RE: 14 Tallwoods Road. Tax Map 107.02 – 1 - 17, - Responses to Town Engineer and  
Town Planner Comments

## **RESPONSES TO TOWN ENGINEER COMMENTS**

**JUNGERS STARR RESIDENCE POOL**  
14 TALLWOODS ROAD  
TOWN OF NORTH CASTLE  
WESTCHESTER COUNTY, NEW YORK

**WETLAND MITIGATION PLAN**  
FOR  
**THE STARR RESIDENCE**  
14 TALLWOODS ROAD  
NORTH CASTLE, N.Y.

TITLE:  
**OVERALL SITE PLAN**

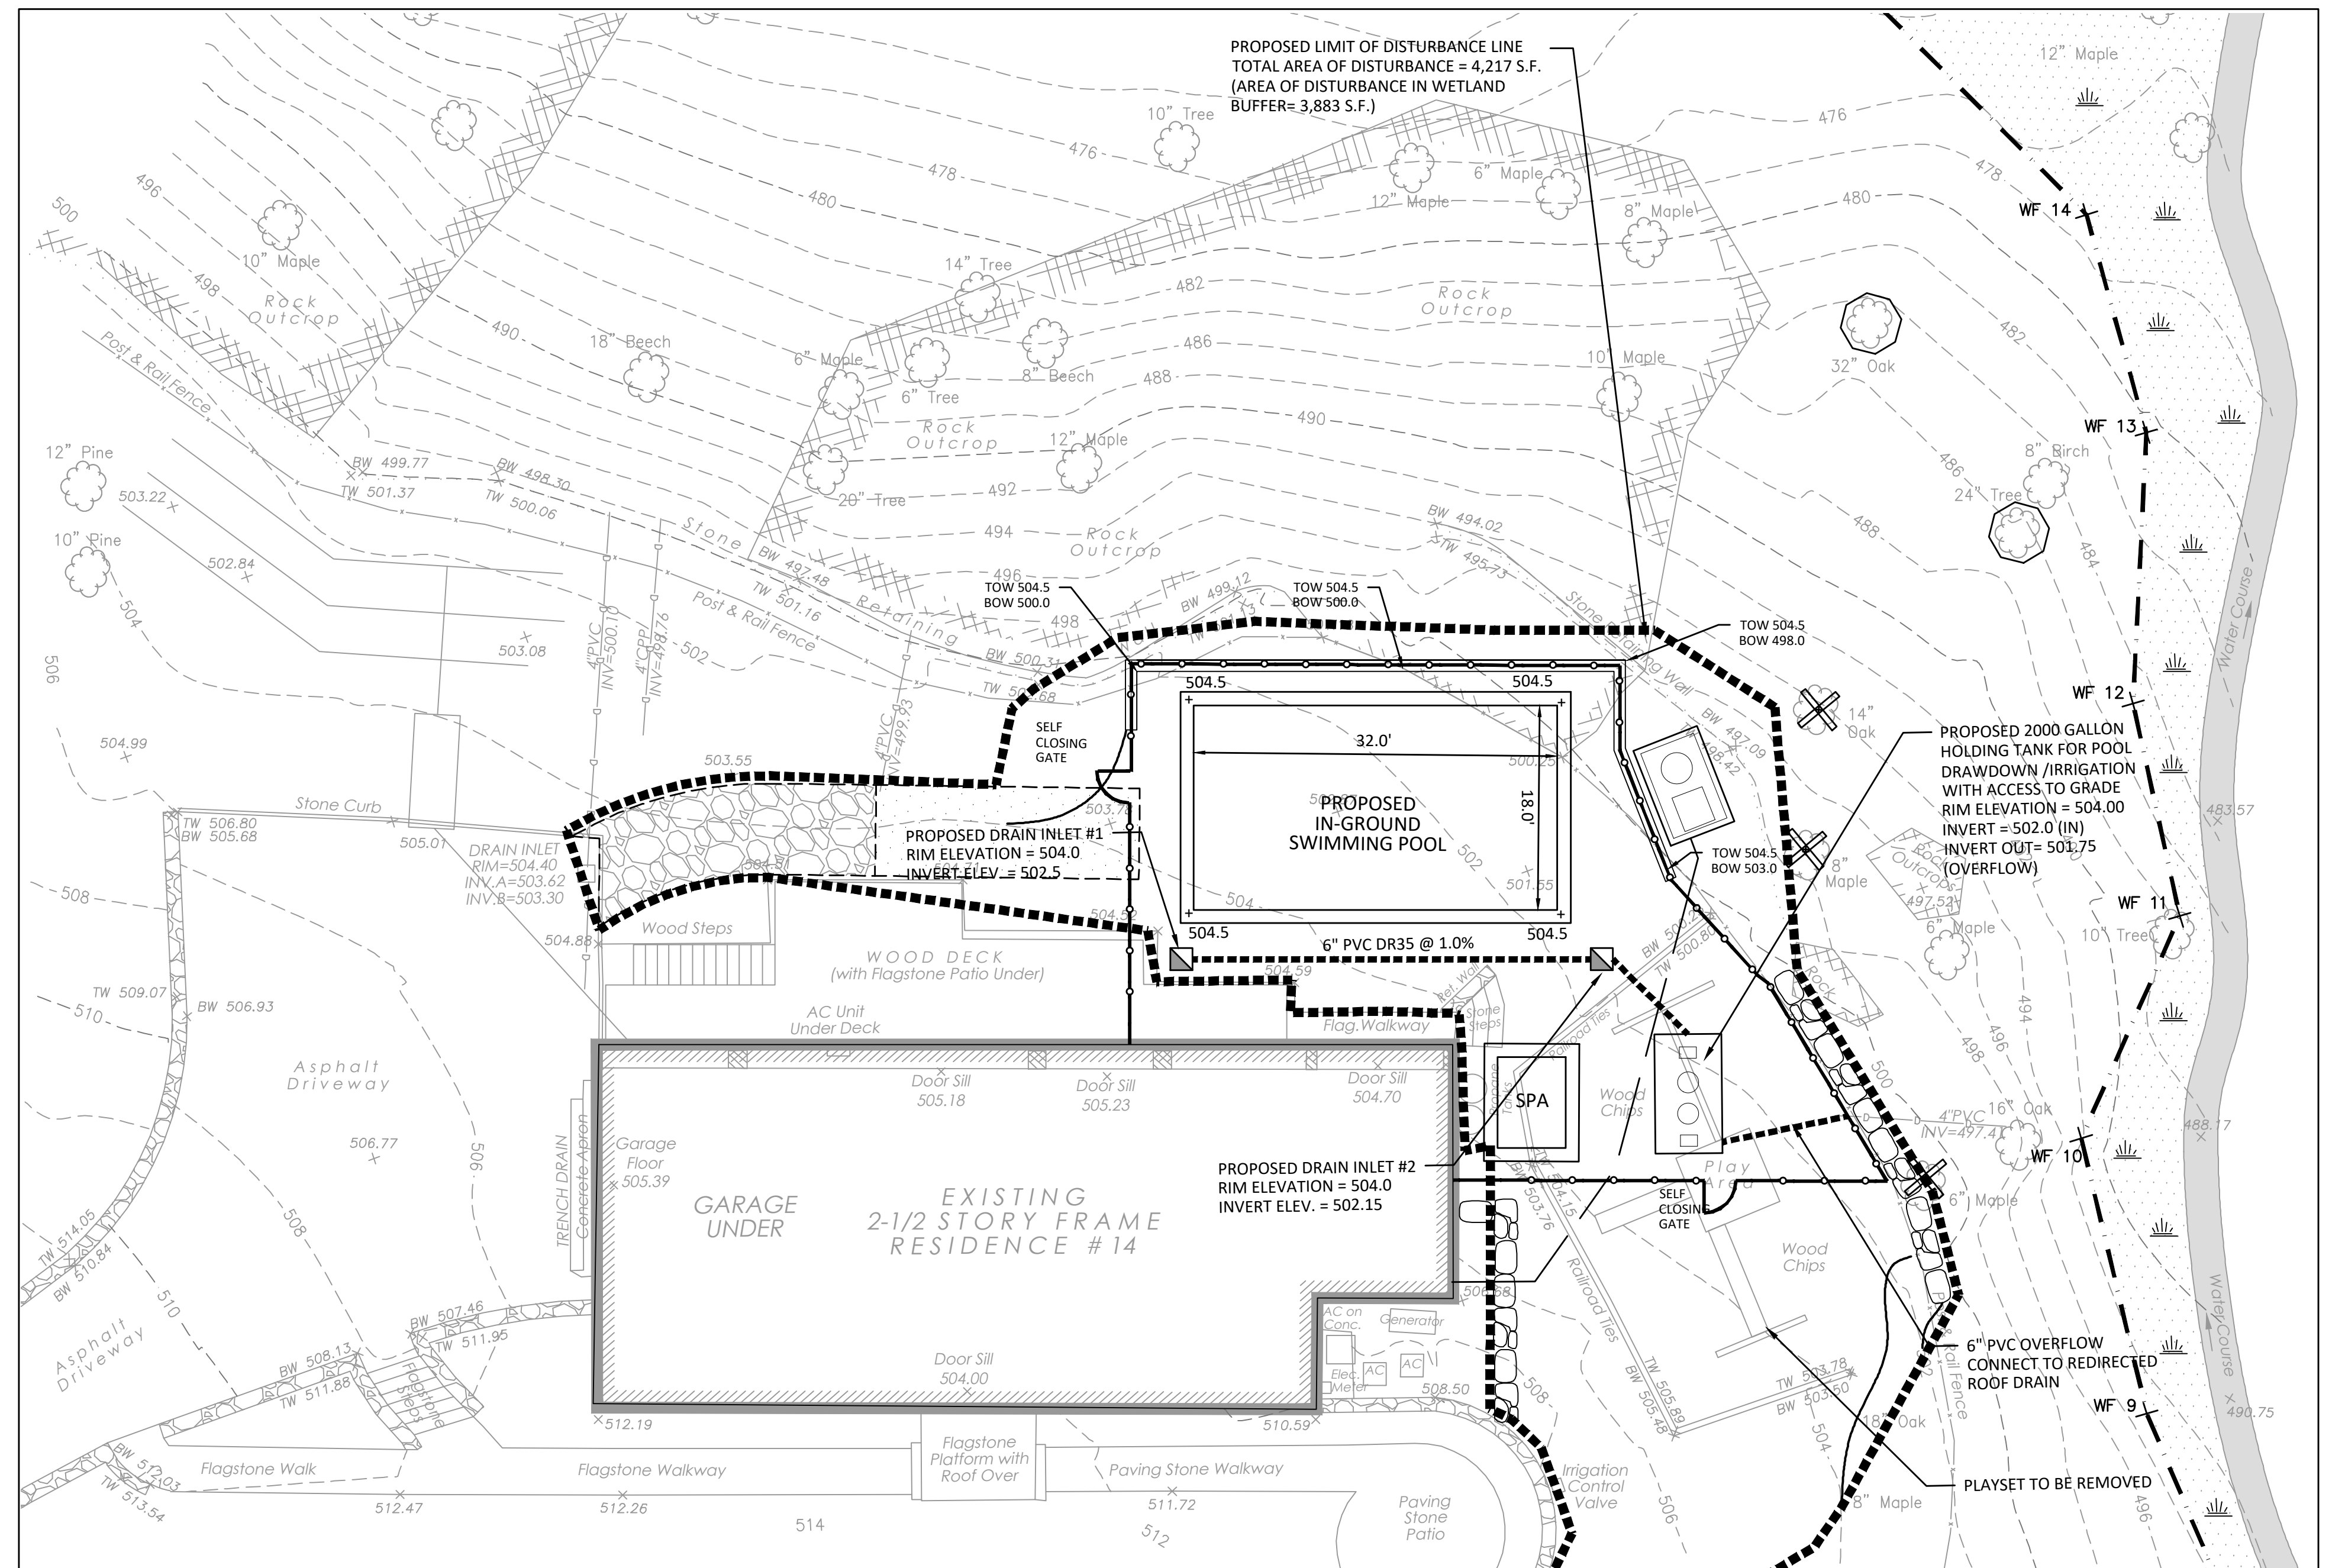
4. *The proposed pool and pool patio are located along the top of the hillside within the rear of the existing residence. In an effort to minimize land disturbance the applicant is proposing a retaining wall along three (3) sides of the pool patio. The walls extend to a maximum height of 9.5 feet.*

*The applicant should provide construction details of the retaining wall, inclusive of design calculations for bearing, sliding and overturning. The plans should also note that the applicant shall retain the services of a Professional Engineer who will inspect the work and provide certification that the work is in conformance with the approved plans, prior to the issuance of a Certificate of Occupancy for the work.*

2. *The pool is retained by a proposed 10 foot retaining wall. The wall may be visible from 8 Tallwoods Road. The plans should be revised to include details of the proposed wall and specifically highlight proposed construction material.*

**Response:** The revised plan does indicate a retaining wall along three sides of the pool in order to minimize disturbance. As a result of the plan revisions, the pool and proposed retaining wall have been shifted uphill and now avoid the Town designated steep slopes. The maximum height of the proposed retaining wall is 6 feet. Structural details will be prepared and include required calculations.

**Response:** The height of the proposed retaining wall will range between 2 feet to 6.5 feet. Structural details of the wall will be prepared and submitted for review. The mitigation planting plan has been updated to reflect 12 Blue Girl Holly, 5-6 feet in

**height placed along the base of the proposed wall to provide screening to 8 Tallwoods Road.**

**2000 GALLON HOLDING TANK DETAIL**  
NOT TO SCALE  
12

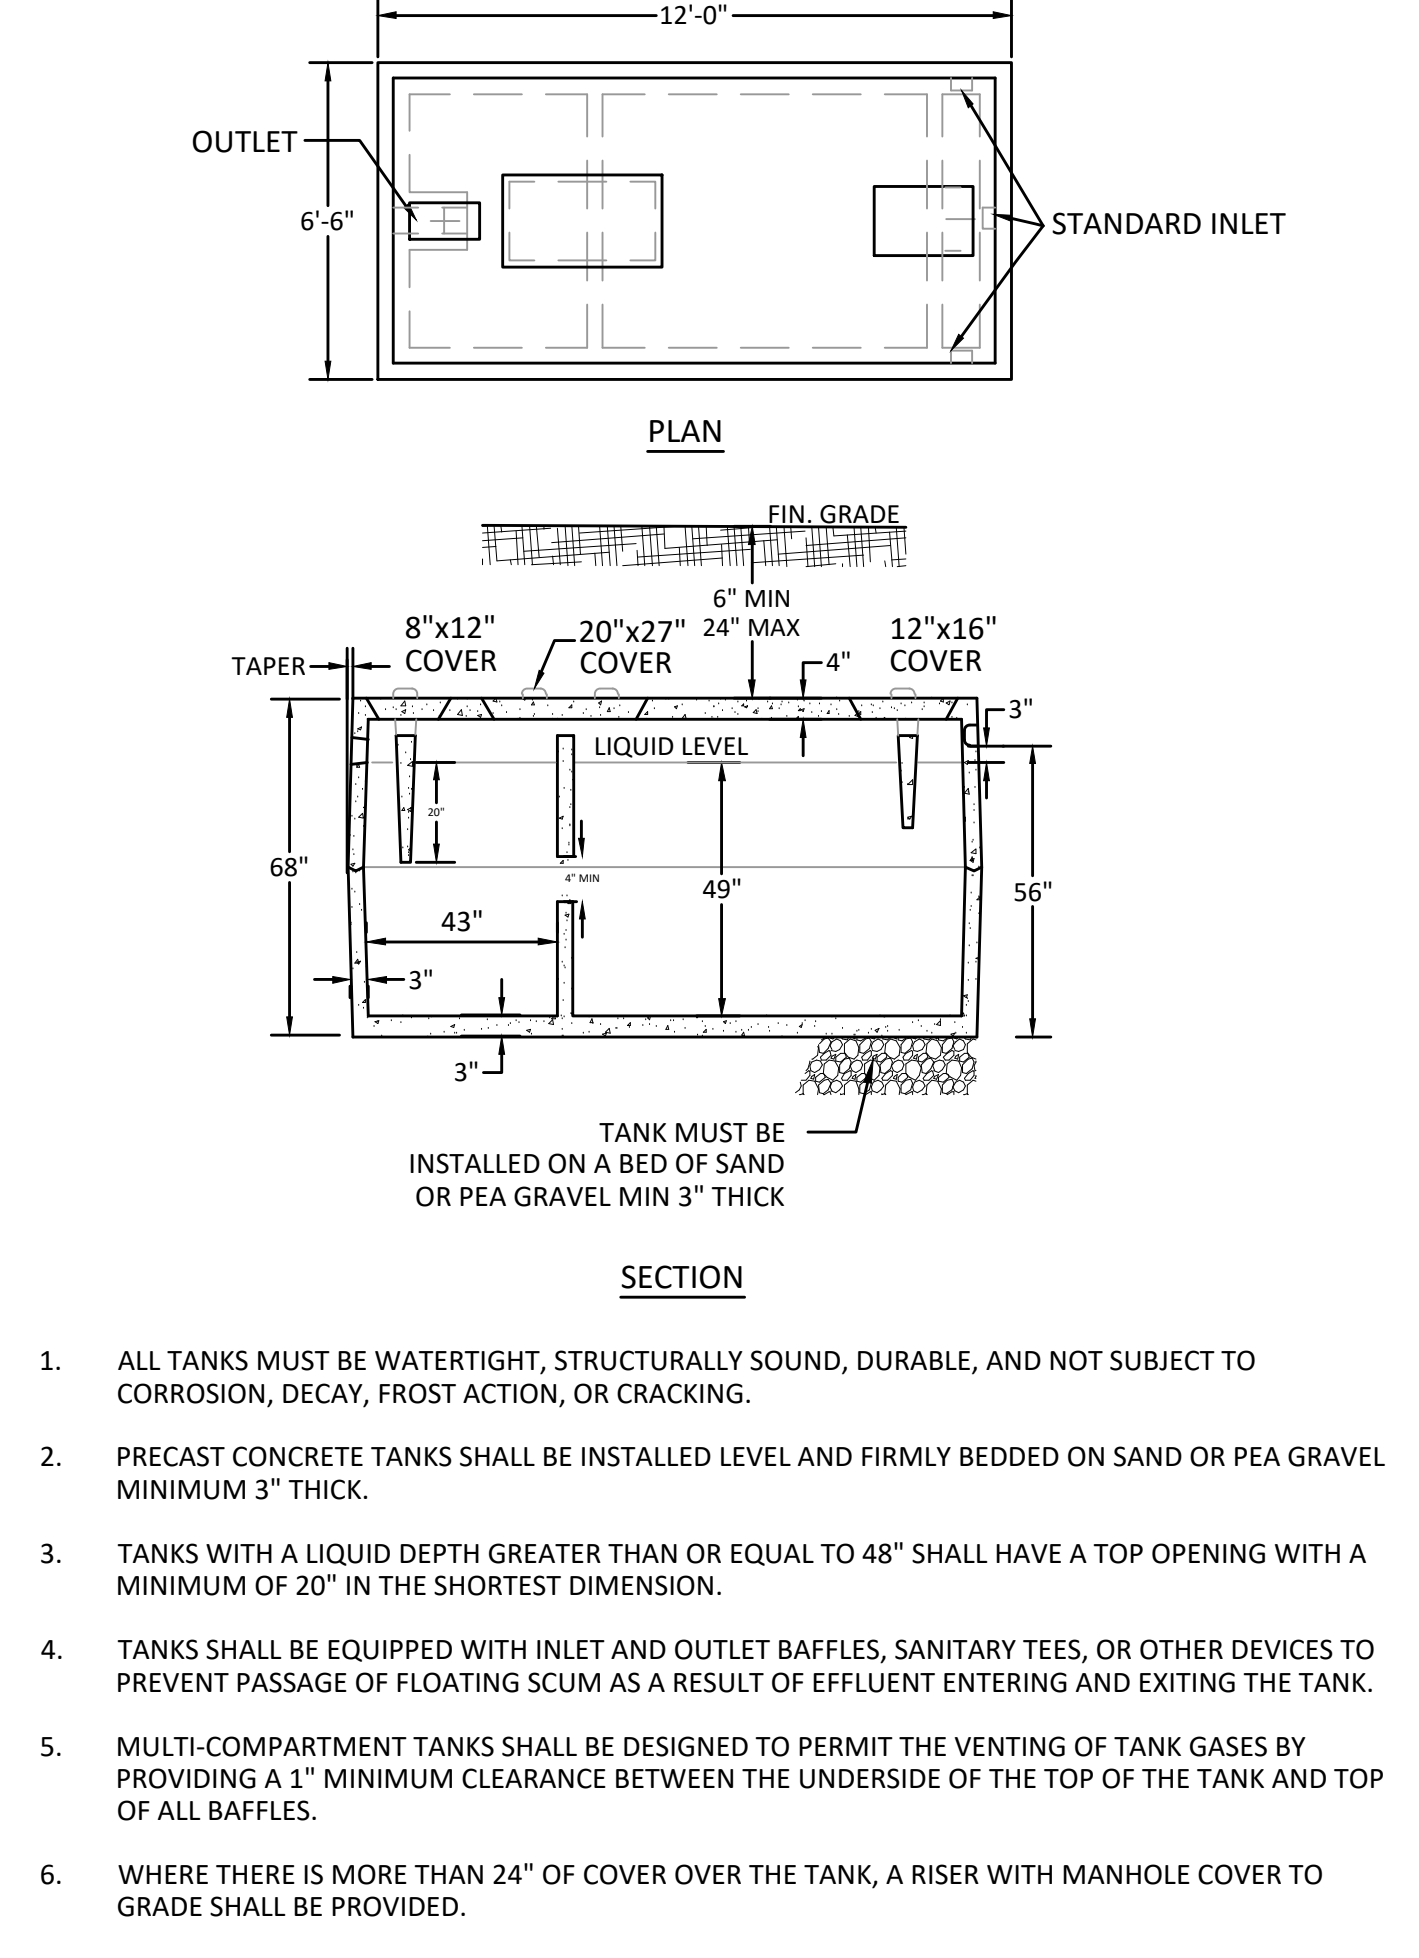
6. *Provide stormwater mitigation and design calculation for the runoff generated by the net increase in impervious surface for the 100-year, 24 hour design storm event. Provide details for the stormwater mitigation system.*

**Response:** In order to minimize impacts to wetland buffer and steep slopes, the entire pool has been relocated uphill and reduces in size. In addition, a patio is no longer proposed. The plan has been updated to reflect a 2,000 gallon holding tank to accommodate pool drawdown. The stored water will be used for irrigation purposes. The 2,000 gallon tank will accommodate the volume associated with a 6" pool drawdown.

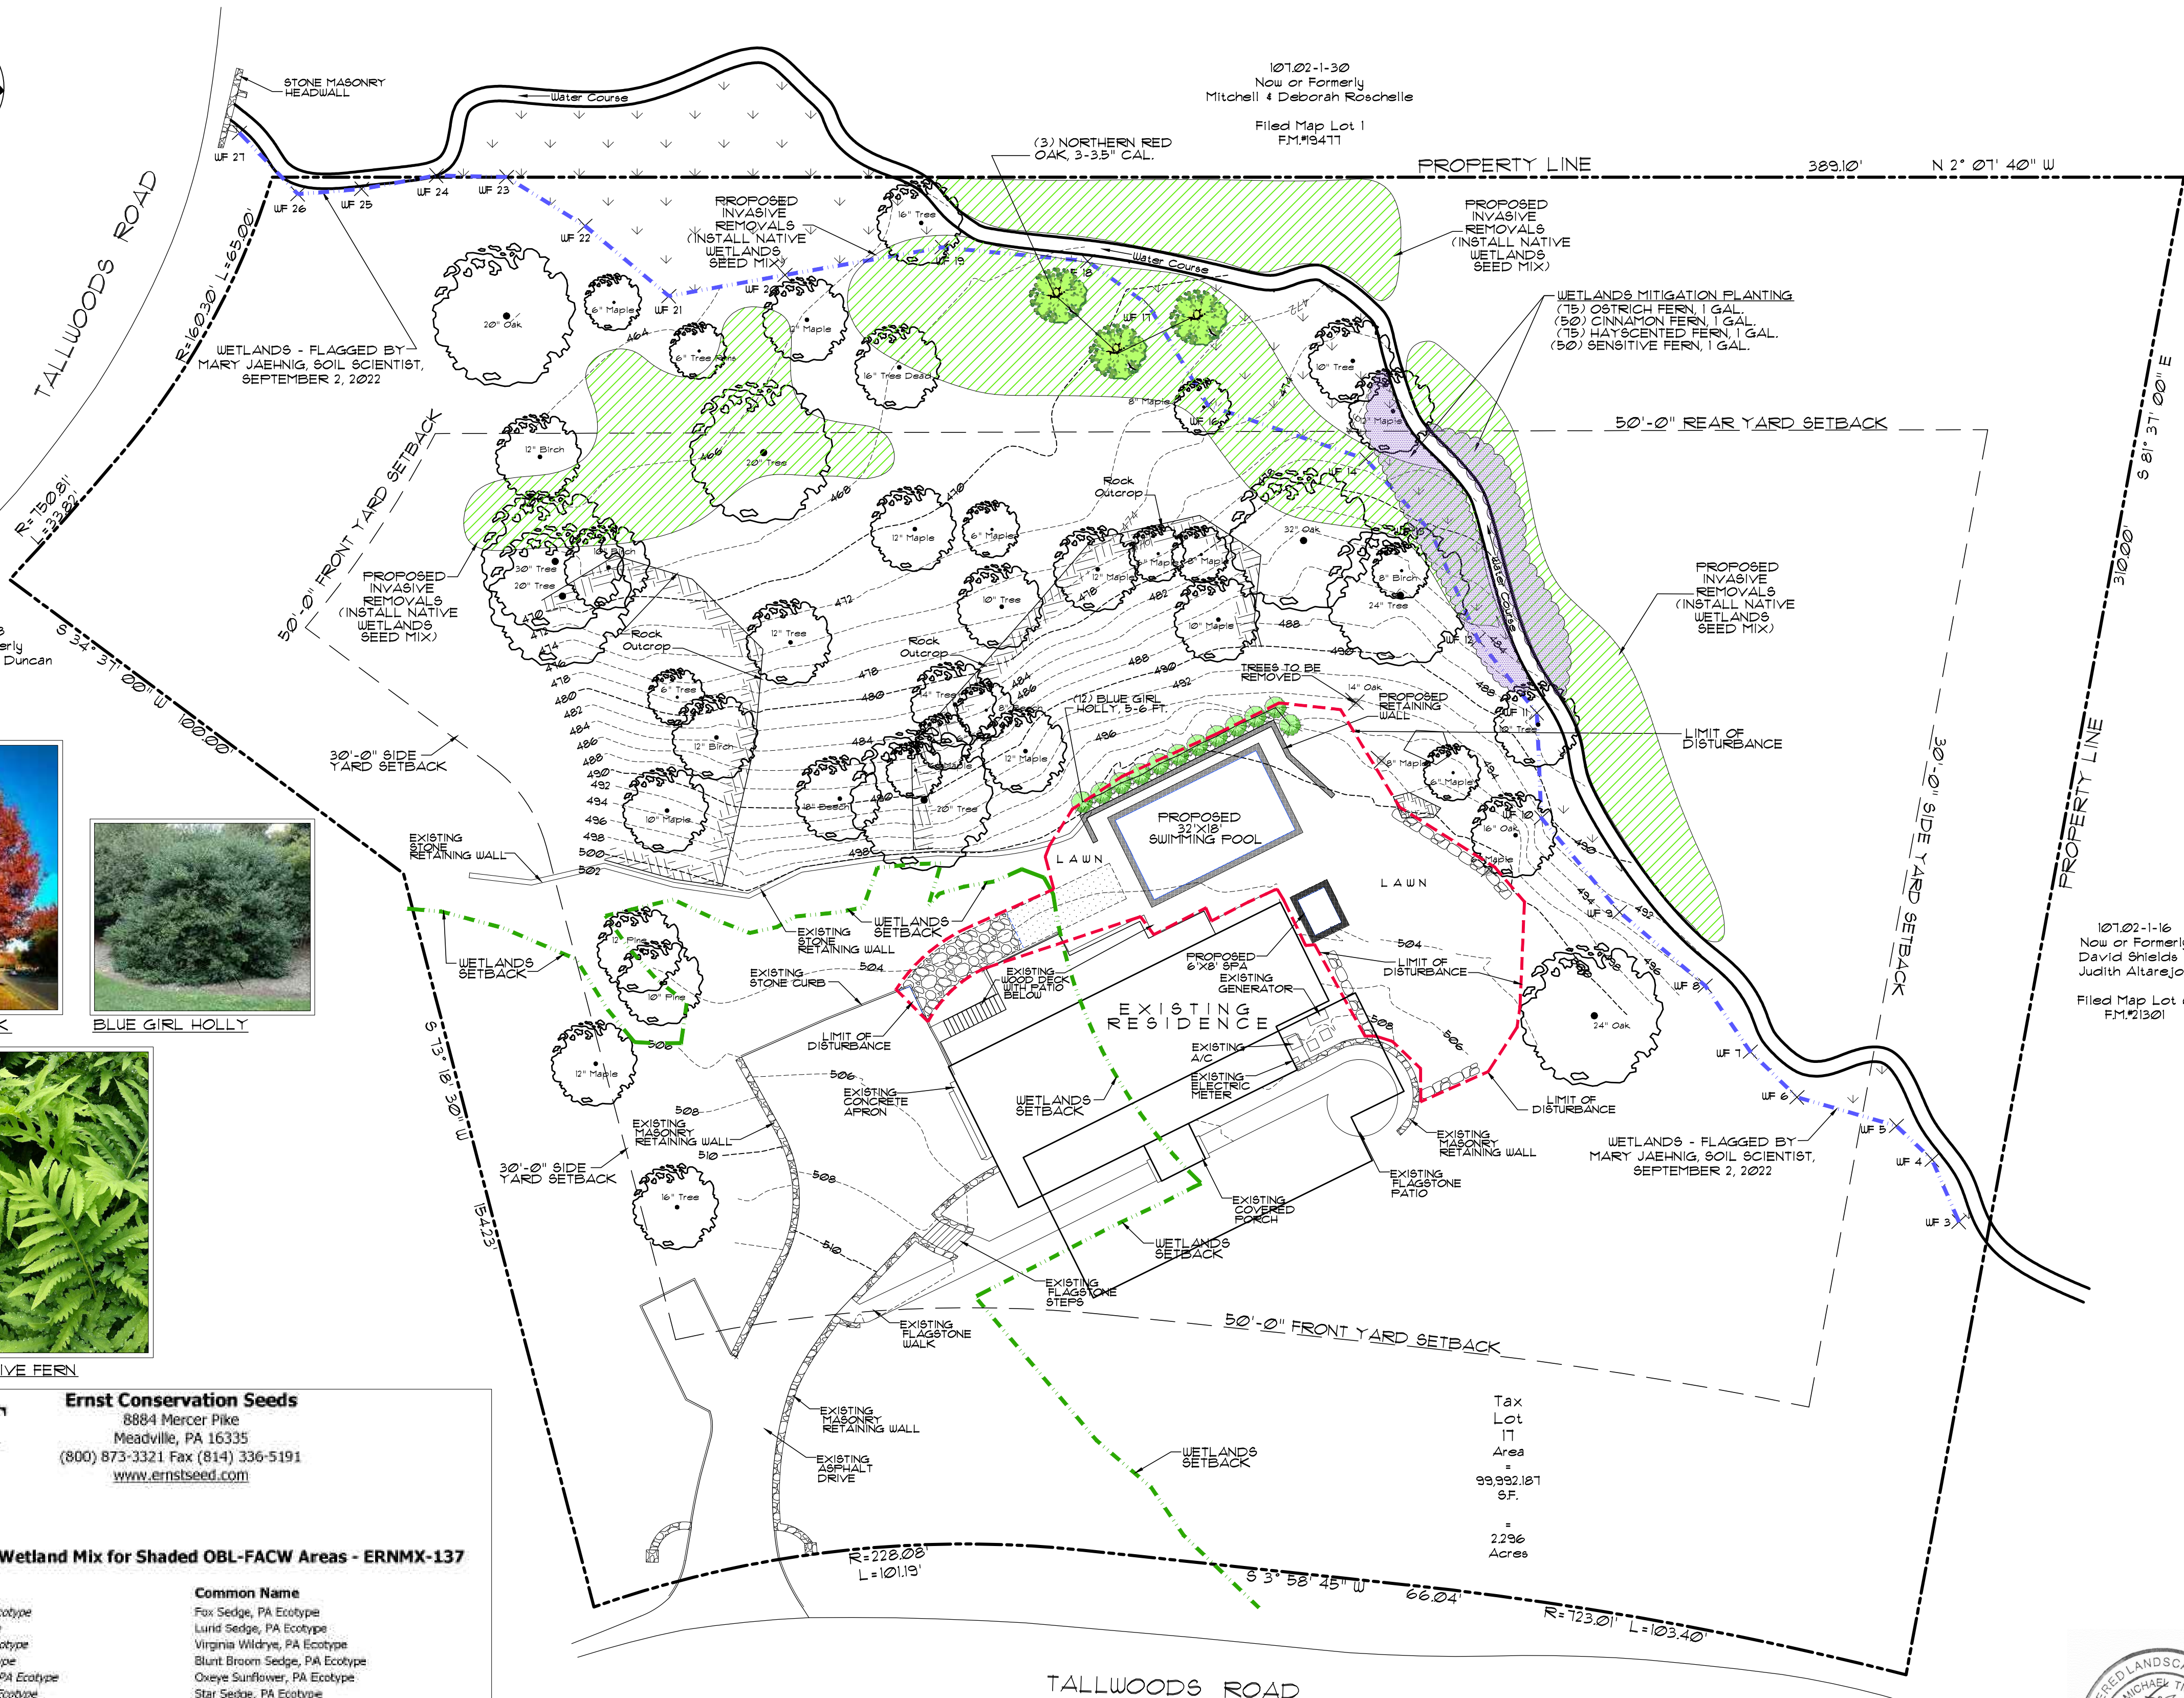
- 2. The proposed project is projected to disturb 5,260 s.f. of wetland buffer. The applicant has prepared a Wetland Mitigation Plan, which included 10,733 s.f. of wetland mitigation, 9,407 s.f. of invasive vegetation removal and 1,236 s.f. of mitigation plantings. A five (5) year wetland monitoring and maintenance plan has been outlined by the applicant.*

3. *The Site Plan depicts 5,260 square feet of Town-regulated wetland buffer disturbance. A 10,520 square foot mitigation plan has been submitted for review by the Planning Board and Conservation Board.*

4. *The Planning Board will need to determine wither the proposed tree removal is acceptable. Three (3) trees are proposed for removal.*

disturbance is 4,217 sf of which 3,883 s.f. is within the wetland buffer. The Wetland Mitigation Plan now provides for a total of 9,344 s.f of mitigation (8,290 s.f. of invasive removal and 1,054 s.f. of mitigation planting) where the required mitigation is 7,766 s.f. A positive referral to the Planning Board was received at the Conservation Board meeting of November 21, 2023. A cost estimate has been prepared and is attached for your review.

**Response:** The total area of disturbance is now 4,217 sf of which 3,883 s.f. is within the wetland buffer. The Wetland Mitigation Plan now provides for a total of 9,344 s.f of mitigation (8,290 s.f. of invasive removal and 1,054 s.f. of mitigation planting) where the required mitigation is 7,766 s.f.

**Response:** Revised plans now indicate 2 trees to be removed. The Mitigation Plan proposes three trees to replace those being removed.
